AMENDMENT NO. 4

NEERABUP INDUSTRIAL AREA

AGREED STRUCTURE PLAN NO. 17

Structure Plan Ref: WANN/2015/17 - 4

Proposed Revised Plan 2: Final Surface Contours Plan (August 2015)

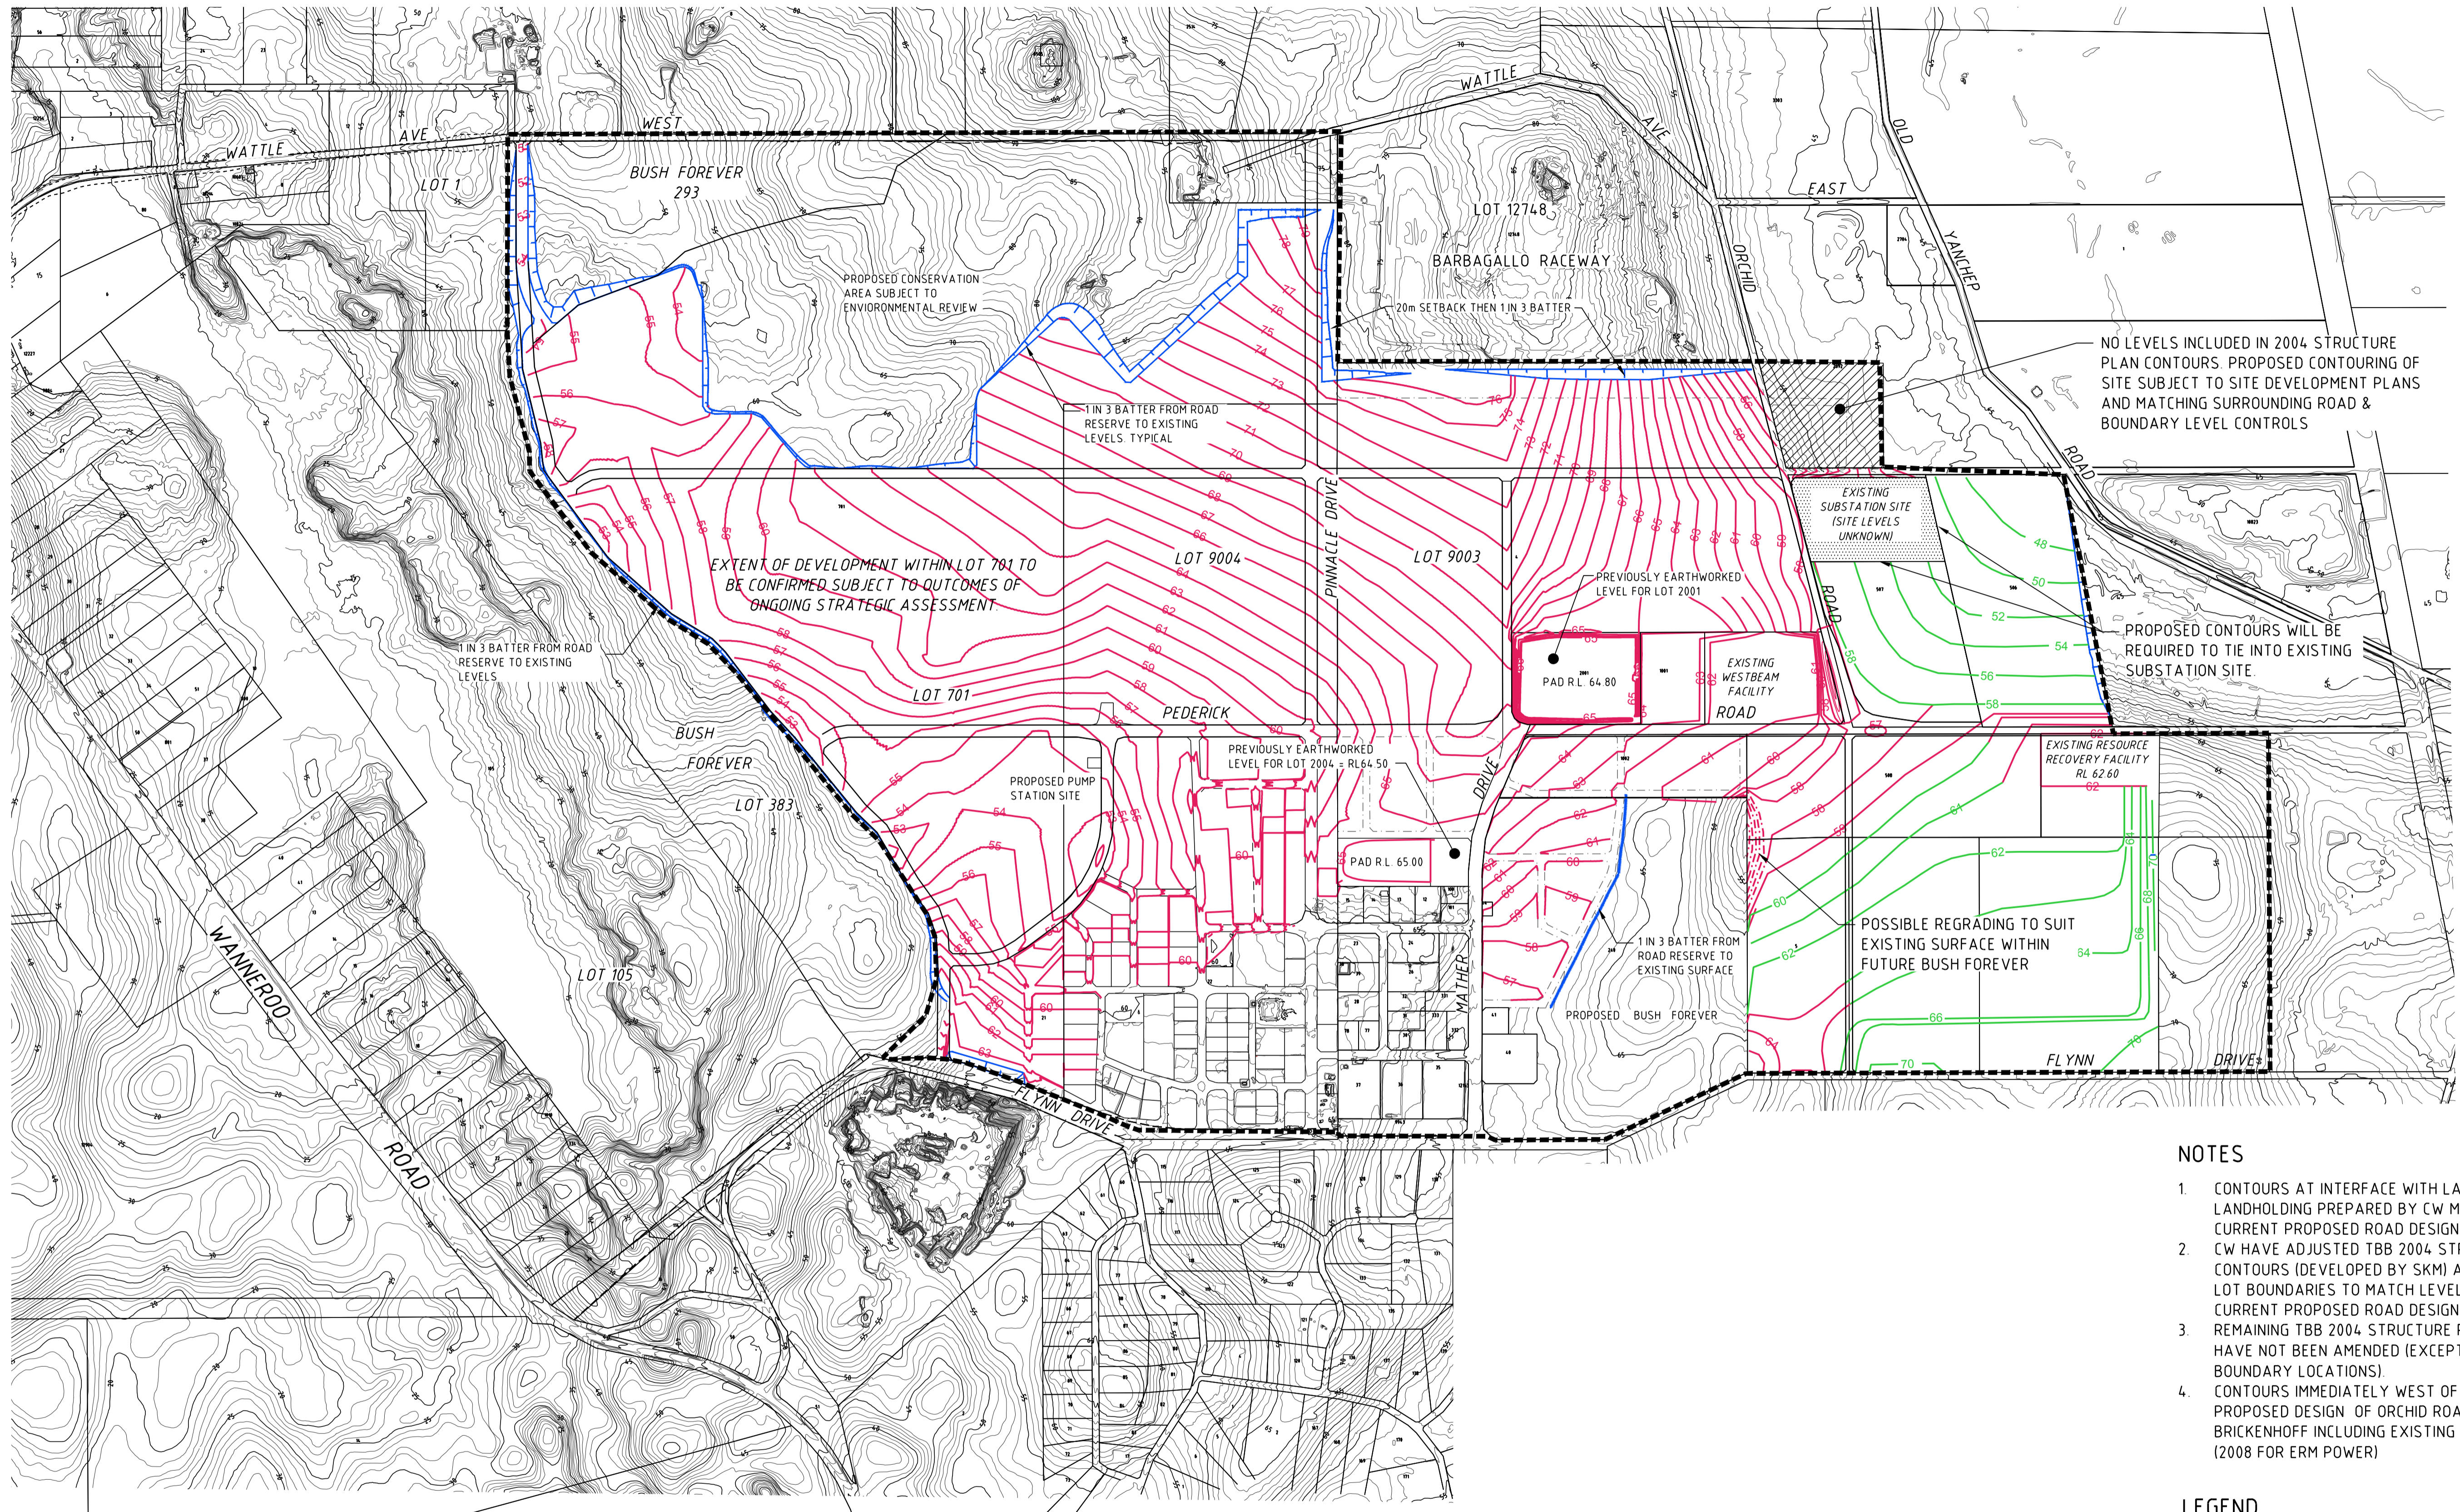
- i. Under Part 1, replacing *Plan 2 Neerabup Industrial Area Final Surface Contour Plan (Sept 2004)* with the updated *Plan 2 Neerabup Industrial Area Final Surface Contour Plan (December 2015)* under Attachment 1 to modify the surface contours.

- ii. Under Part 2, replacing Figure 6.1: *Neerabup Industrial Area Final Surface Contour Plan (Sept 2004)* with the updated *Figure 6.1 Neerabup Industrial Area Final Surface Contour Plan (December 2015)* under Attachment 1 to modify the surface contours.

Section 6.4.1 of the ASP 17 Explanatory Report states that "a review of the adopted Final Surface Contour Plan may be warranted if resource extraction rates are not enabling the timely supply of industrial land". The revised Final Surface Contour Plan responds by setting new finished levels in light of recent information regarding the anticipated extent of limestone extraction in the area. The revised Plan reduces the amount of cut and fill required to establish those finished levels and rectifies other shortcomings to future development such as acknowledging the existing levels on Mather Drive.

Specifically, the revised Plan:

- Matches contours at the interface between LandCorp and City of Wanneroo landholdings with existing or proposed road design levels;
- Adjusts adopted contours at the interface between roads and lot boundaries to match levels along existing and proposed roads;
- Retains original ASP 17 contours generally east of Mather Drive and Orchid Rad; and
- Reflects existing contours north of Pederick Road relating to previously earthworked levels and the Westbeam facility.

PROJECT
 LOT 22 FLYNN DRIVE, NEERABUP
TITLE
 PROPOSED AMENDED STRUCTURE PLAN CONTOURS 2015
DRAWING No. 5920-00-SK126
REVISION E

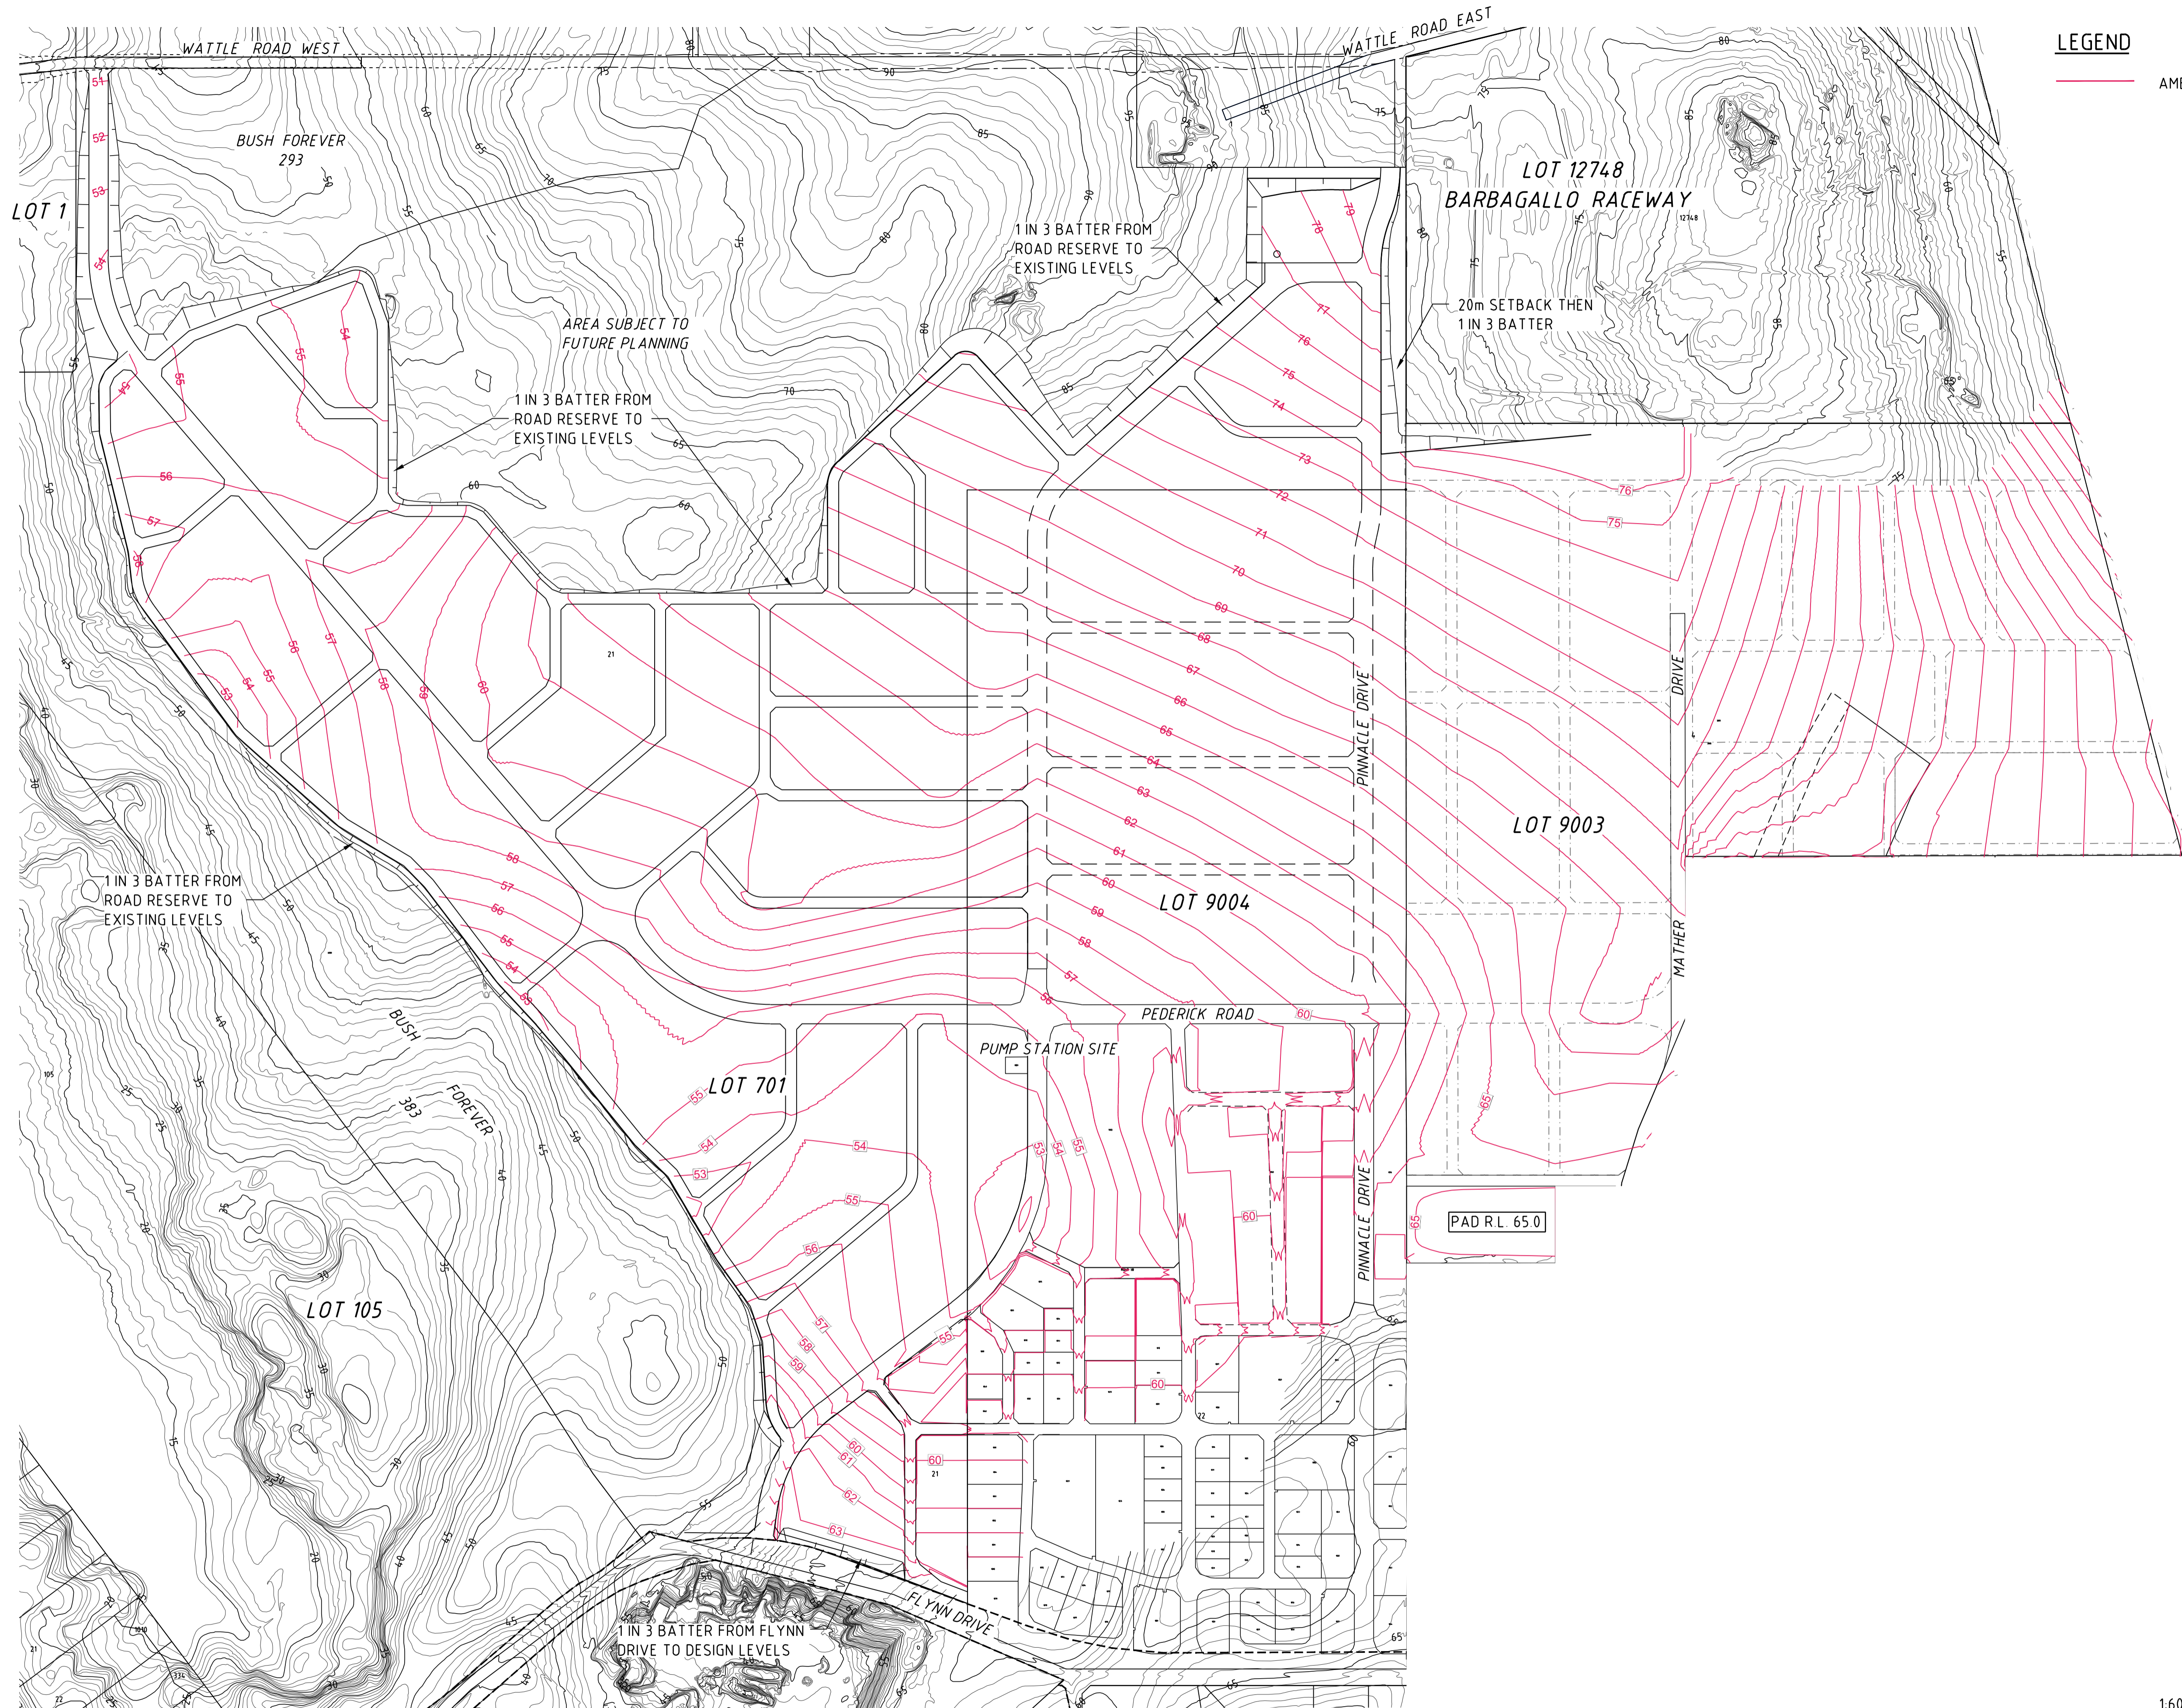
- The design levels proposed by Landcorp for the land east of Lot 9004 including Lot 9003 (see figure 1) are acceptable to DMP. These levels do not extract to the full depth of the known limestone, however, the available drilling information indicates that the grade of this material is comparatively low, averaging less than 60% CaCO₃. Part of this consideration is in recognition of the practical constraints on the final levels, particularly the current level of Mather Drive and the adjacent high voltage power lines. Of course, DMP encourages extraction below these design levels if economics permit.

- The proposed design levels for Lots 701 and 9004 (see figure 1) are acceptable to DMP subject to additional extraction of limestone beneath these levels where economics permit. DMP understands that excess sand onsite may be used as fill material to achieve final design levels. This additional extraction is consistent with current and past practice on Lot 9004 and thus far has resulted in good overall outcomes for limestone production and land development. Note drilling information shows areas of limestone up to about 20 m thick beneath the proposed design levels (refer to figures 2, 3, 4 and 5). Parts of the thicker limestone on the western side of Lot 701 are of very good quality and DMP expects maximum extraction of limestone within these areas where economic and practical quarrying considerations permit.
